Sent: 22 February 2026 23:05
To: Planning
Subject: DC/25/2114 + 2 photo attachments
Categories: Comments Received

Height of vegetation prior to flailing

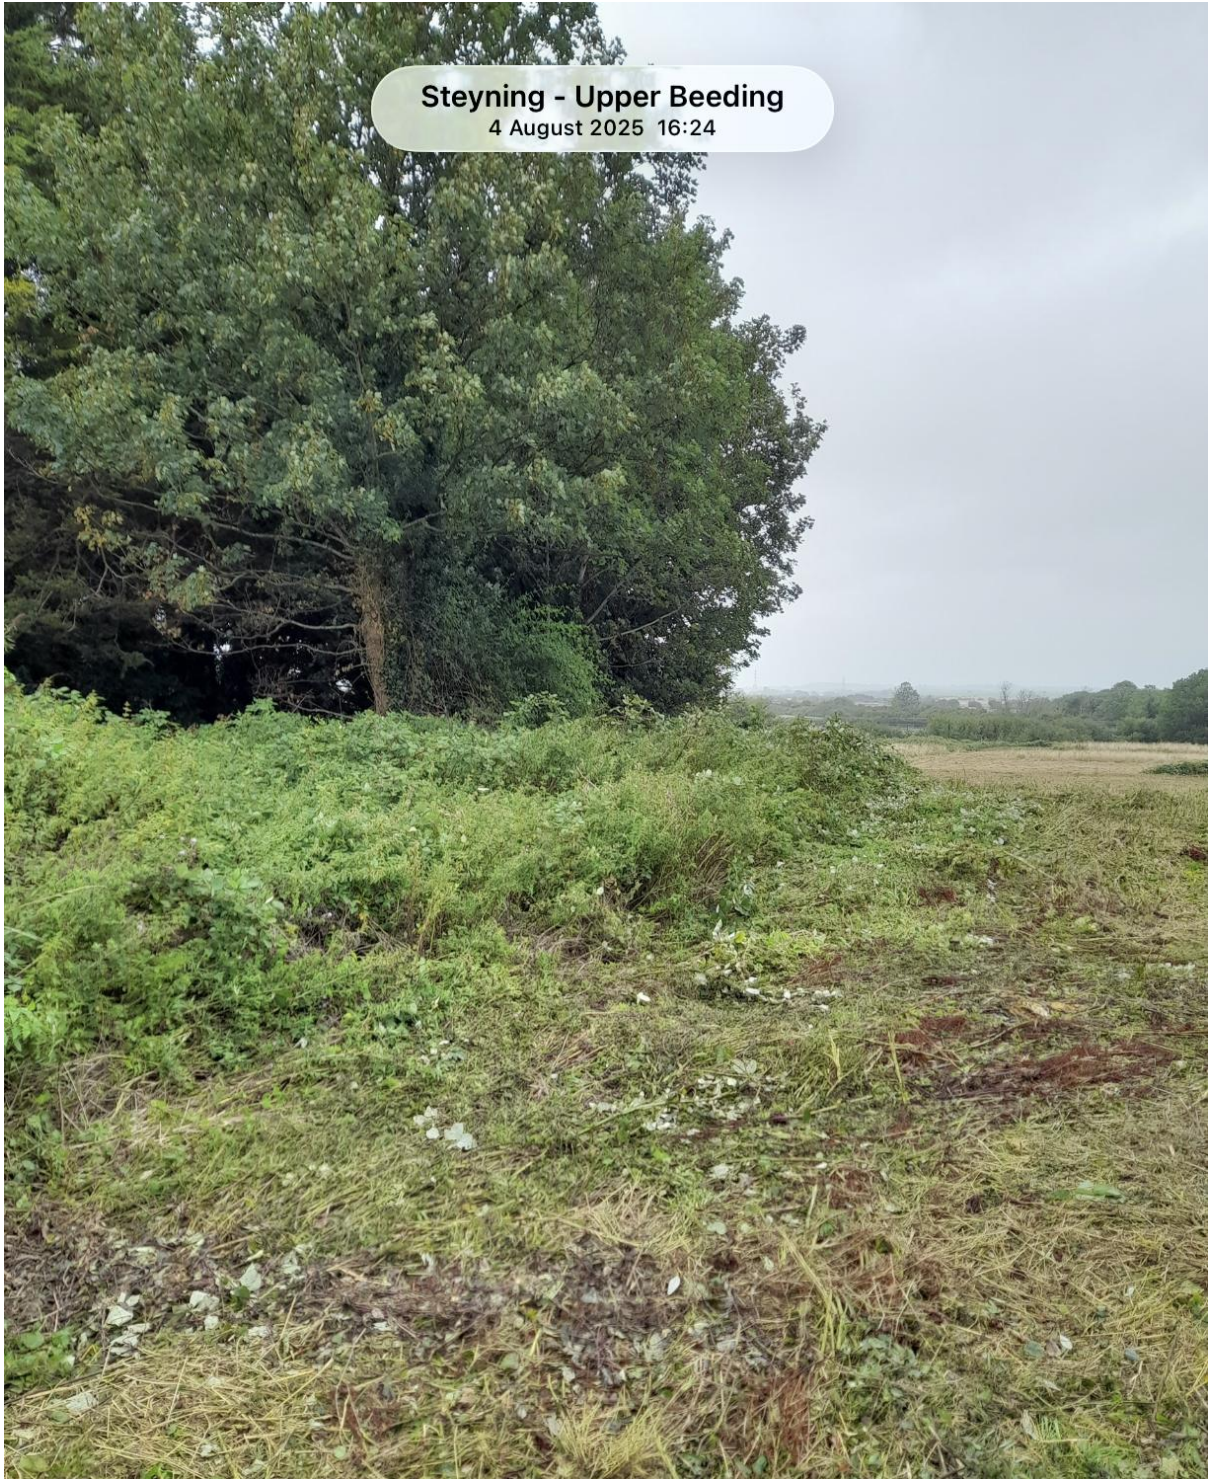
This is factually incorrect. No dense bramble scrub was removed between 2021 or 'managed' in any shape or form..... and until August 4th 2025it is highly misleading to say that and the **remaining** scrub had been recently flailed....this was fully regrown vegetation at chest height.

As a resident living in immediate proximity to the site, with direct and regular views of the land over a number of years, I have observed the condition or if there were any management of the bramble and blackthorn scrub throughout multiple seasons. The field was flailed in 2021 and, to my knowledge and observation, remained unmanaged thereafter until a further flailing that took place on 4th August 2025.

Instead, the vegetation has developed as dense, undisturbed scrub consistent with extended periods of natural growth rather than routine cutting.

This discrepancy suggests that the baseline habitat condition may not have been accurately represented not to mention a full clearance of the entire field one week prior to Eco Co Ops survey and therefore the ecological conclusions and proposed mitigation measures should be reviewed to ensure they are founded upon an accurate understanding of the site.
